## 4725 Cheltenham Drive, Sketch Plan No. 320200060

### Description

- Sketch Plan: Request for up to 80,000 square feet of density for residential development, with a minimum of 15% MPDUs; the maximum density includes a future allocation of up to 35,596 square feet of density from the Bethesda Overlay Zone (BOZ) with a Park Impact Payment (PIP); Current use: single-story automotive repair shop and associated surface parking lot;
- Located approximately 110 feet east of Wisconsin Avenue in the Wisconsin Avenue Corridor District.
- 0.25 acres zoned CR 3.0 C 2.0 R 2.75 H 90' in the 2017 *Bethesda Downtown Sector Plan*;
- Applicant: Bozzuto Development Company;
- Acceptance date: August 10, 2020.

*Figure 4 – Conceptual massing options of building*

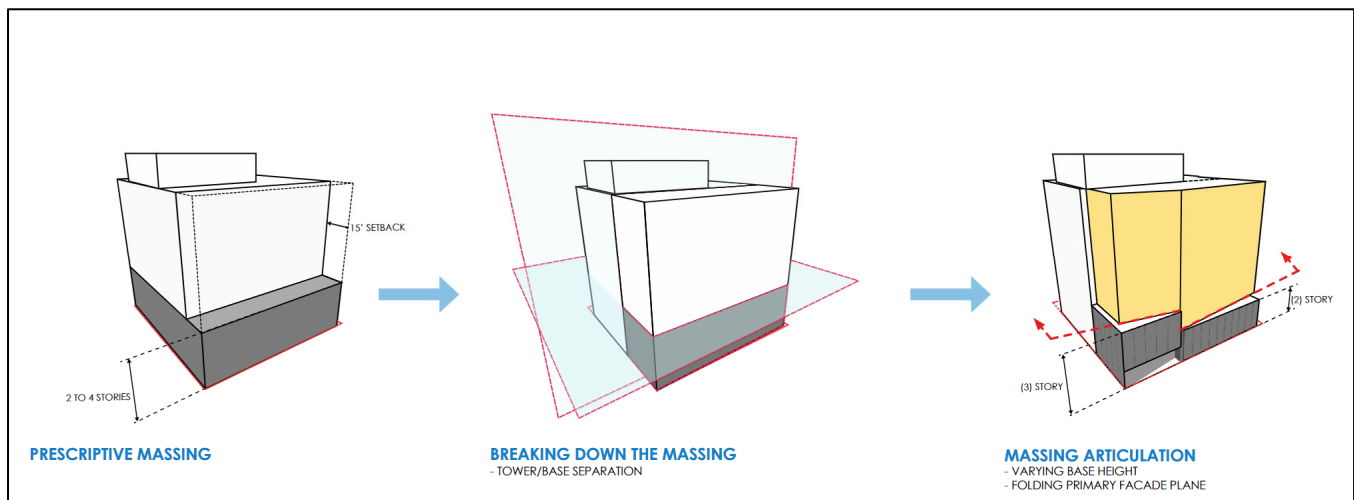
- a. Relationship of the building and site design to Cheltenham Urban Park;
- b. Articulation of massing at entry with regard to future development of property to west; and
- c. Treatment of western façade with greater articulation and potentially to extend northwest corner units to increase access to light and air.

- Project is moving in the right direction, the party wall sketch does show projection and wonder if there is more opportunity to extend the elements above the roof line to enhance interest.

- *Applicant Response: We appreciate that comment, we were trying to create a sense of entry but if a new project does come next to us they could potentially build out above the entry, and it may or may not. We will do a massing study.*

Figure 5 – Building Section (through Cheltenham Drive looking east)

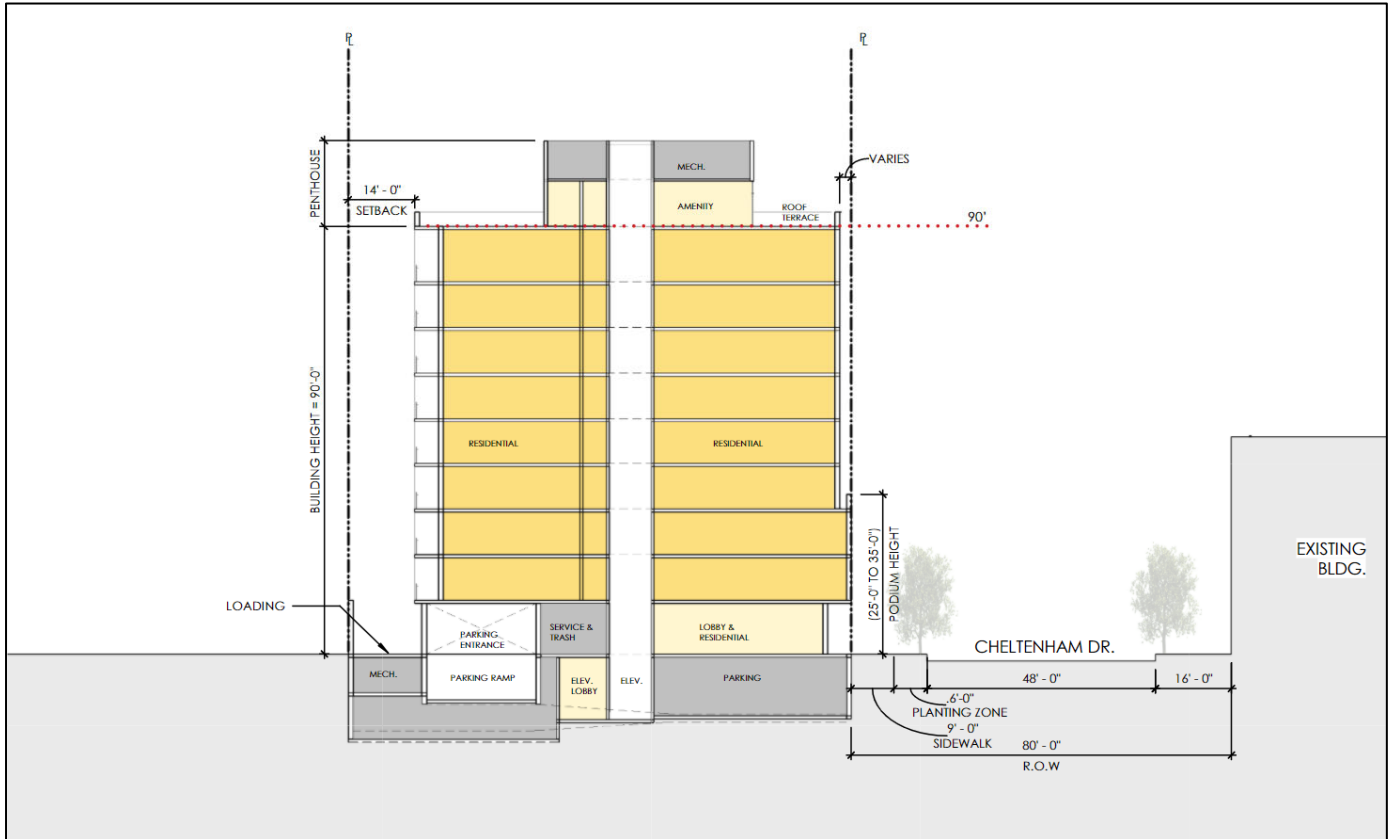
- Previously we requested a section through the property and into the Cheltenham Park to show the existing slope moving across the alley into the park. Disappointed that all the exhibits look relatively flat knowing the existing condition is otherwise. That detail is going to be very important as how it is handled with the relationship to the park and those using the park.

- *Applicant Response: Apologize for not providing, we can certainly provide that. The fence has recently been repaired and has extended along the Park property line, we tried to address the relationship with specialty paving to signal that the Alley is more than an Alley, rather a front of the Project.*
